ARÇELİK	PART - GROUP CHANGE NOTIFICATION				Bulletin no	2002-01	Date	10.06.2002	
	Prepared by	Hakan Amaç-Yaşar Ceylan				Signature			
	Approved by								
Copy to	TH-YPLB	✓	ÇMİ-MTK1	✓	ÇMİ-ÜPB		Other		
	ÇMİ-KGB	✓	ÇMİ-MTK2	✓	ÇMİ-MÜT		Other

TECHNICAL EXPLANATION OF THE CHANGE

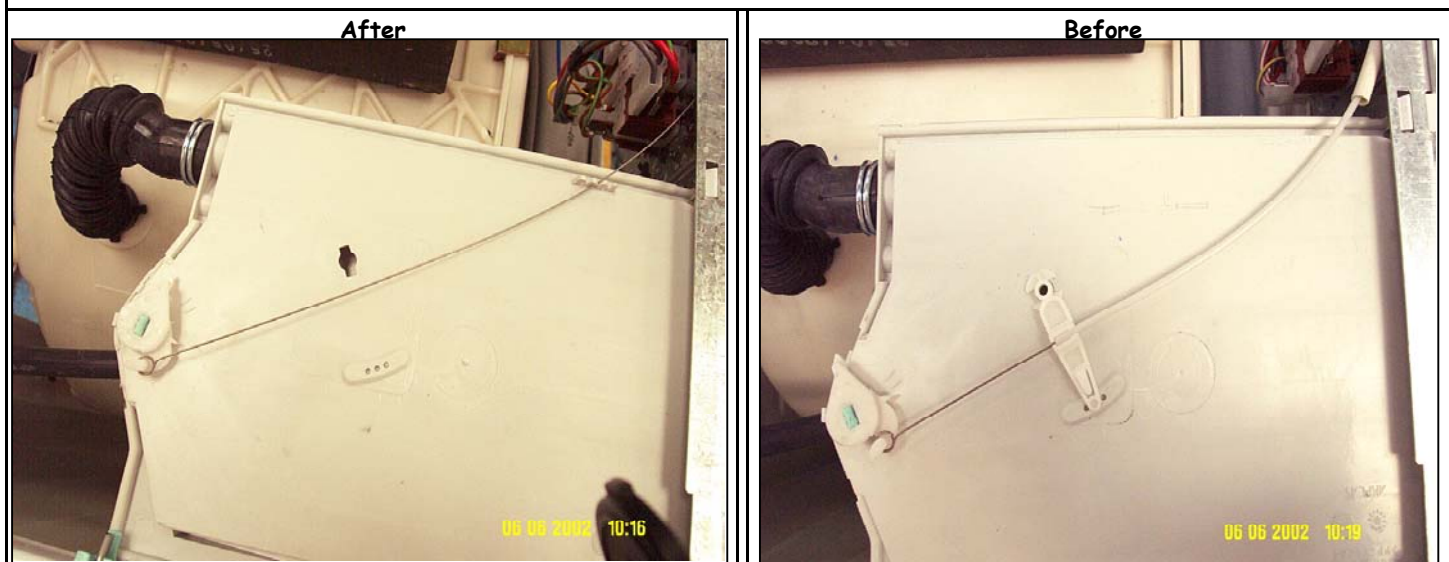
Issue	Water Diverting System Change
Explanation	<p>In order to improve water diverting system, below modifications have been made in Arçelik washing machines:</p> <p>1) Adjustment part (2800960100) on the detergent box cover has been cancelled. It will not be used any more.</p> <p>2) Movement transmission wire assembly (2801000100) has been changed. The plastic cover of the wire is cancelled and the length of the wire has been shortened. Stock no. of the new wire is 2809010100.</p> <p>3) Detergent box cover is also modified due to the fact that the adjustment part is cancelled. Three clips form have been added in order to fix the wire.</p>

Ref	New part(s)			Old Part(s)			Code
	Part name	Stock number	Rev	Part name	Stock number	Rev	
110	Movement transmission wire assembly.	28 0901 01 00	C	Movement transmission wire assembly.	28 0100 01 00	F	B1
